UNITED STATES OF AMERICA
NUCLEAR REGULATORY COMMISSION

(Clinch River Breeder Reactor)
Plant))

Docket No. 50-537

NRC STAFF'S ANSWERS TO NATURAL RESOURCES
DEFENSE COUNCIL, INC. AND SIERRA CLUB
TWENTY-SEVENTH SET OF INTERROGATORIES TO STAFF

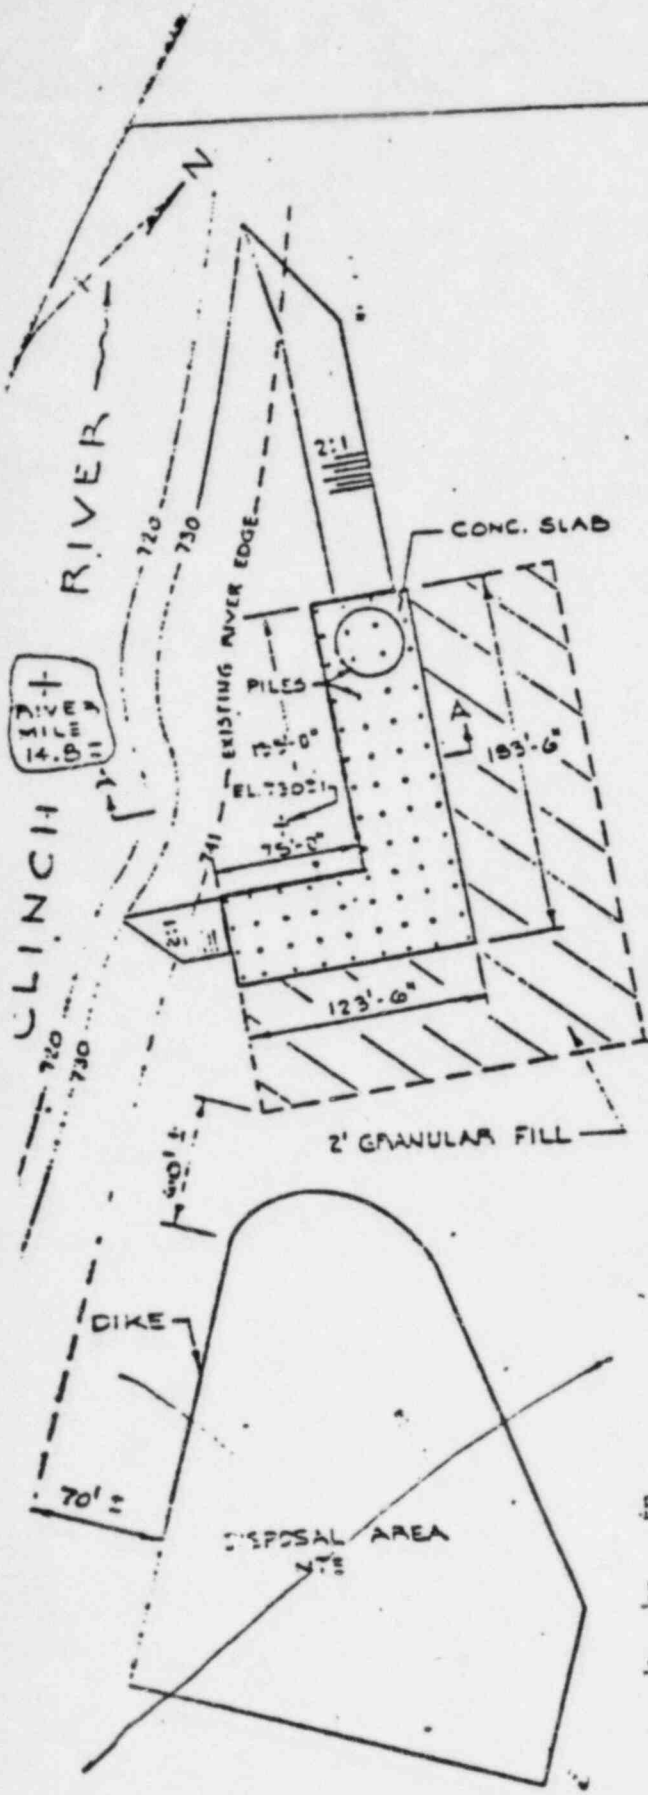
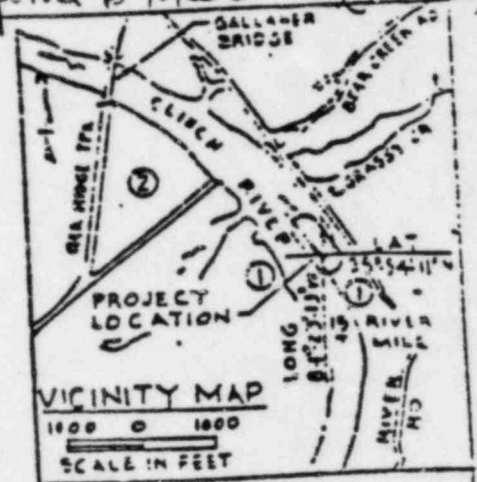
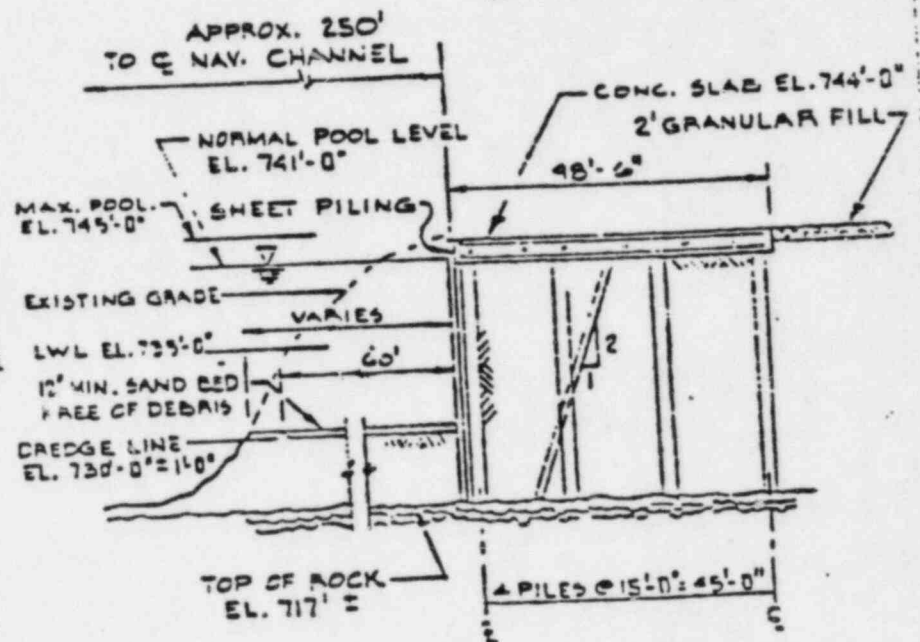
Provide a detailed map showing the current proposed location of the CRBR barge unloading facility to the nearest tenth of a river mile.

Enclosed is a copy of a sketch provided to the Corps of Engineers by DOE in 1981 which shows the proposed barge unloading facility at Clinch River mile 14.8.
